FSB-63 (R1) Flightcell Service Bulletin

To:	Flightcell End Users, OEMs, Distributors, Resellers, Service Centres, and Installers
Subject:	Change in part numbering for the DZP_04 Flightcell DZMx
Effective Date:	16 November 2021
Status:	Optional
Affected Products:	DZP_04-xxx Flightcell DZMx (all product variants)
Affected Serial Numbers:	Various

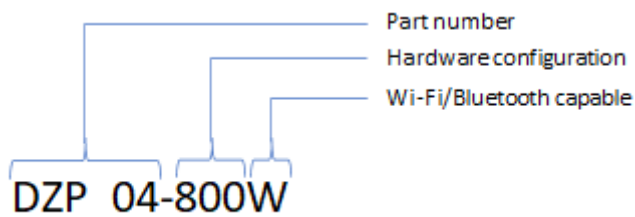
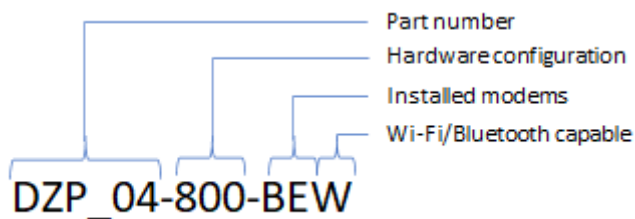
For revisions 1, 2 and 3, the dash number is comprised of 3 or 4 digits, in the format DZP_04-xxxx.

For revisions 4 and later, the dash number is comprised of 3 to 7 digits, in the format DZP_04-xxx-xxxx.

An example of the two numbering systems.

Revision 1,2, or 3: DZP_04-800W, Flightcell DZMx DZUS with Sat, 4GCell & WiFi/BT Capable

Revision 4 and later: DZP_04-800-BEW, Flightcell DZMx DZUS with Sat, Europe Cell & WiFi/BT Capable

The part numbering system is therefore expanded by adding a further group of up to four digits which denote the transceivers (up to three) and whether the DZMx is WiFi capable.
